This addendum forms part of the Bid Documents and alters the original Drawings and Specifications as follows. Acknowledge receipt of this addendum in the space provided on the Bid Form.

Project No. 9E7401 – LHSB Renovations

WU - Labatt Health Sciences Building Renovations
1151 Richmond Street, London ON
N6A 2K5

DRAWING #:
DE 02

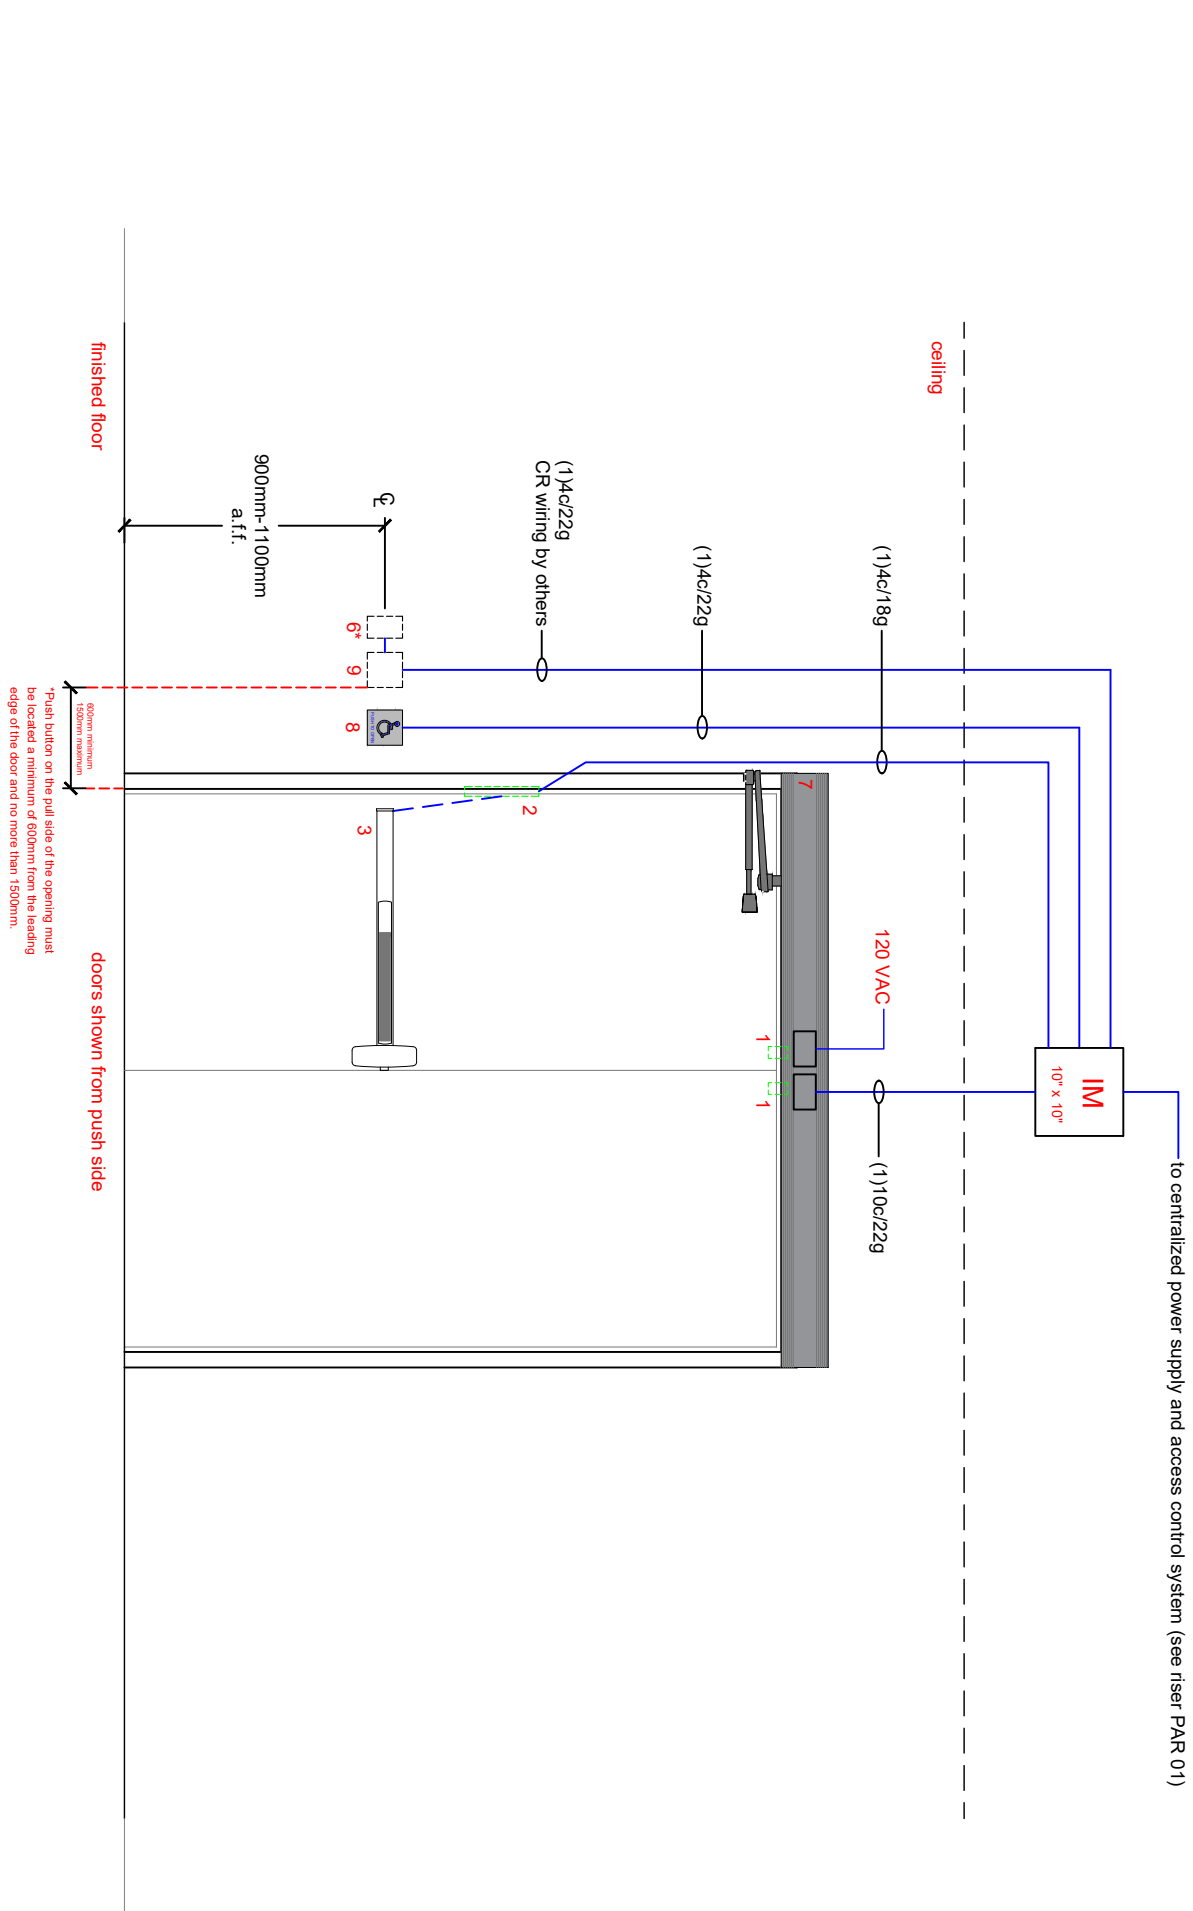
- Q6 What are the manufacturers and type of each of the breaker panels?
- A6 Most existing electrical panels are Eaton PL1A type panels.
- Q7 Refer to Spec 27 05 28 2.3.7 and E2.2 Note 3, E2.4 Note 2: There is no "Door Hardware Elevations" attached to this section, and no rough-in details for conduit and back boxes on any drawings or specs. Please provide this information for the amounts and locations of required rough-in conduits and back boxes for access control devices.

- A7 Refer to Door Hardware Elevation Risers included in this addendum.

- .9 Section 26 20 00 APPENDIX – PANEL SCHEDULES
 - .1 Refer to attached revised panel schedules.
- .10 Section 27 05 28 APPENDIX – DOOR HARDWARE ELEVATIONS
 - .1 ADD Section 27 05 28 Appendix – Door Hardware Elevations. Electrical Contractor to provide a system of empty conduits and boxes indicated on door elevations and denoted by Division 26. All conduits to be complete with nylon fishwire.
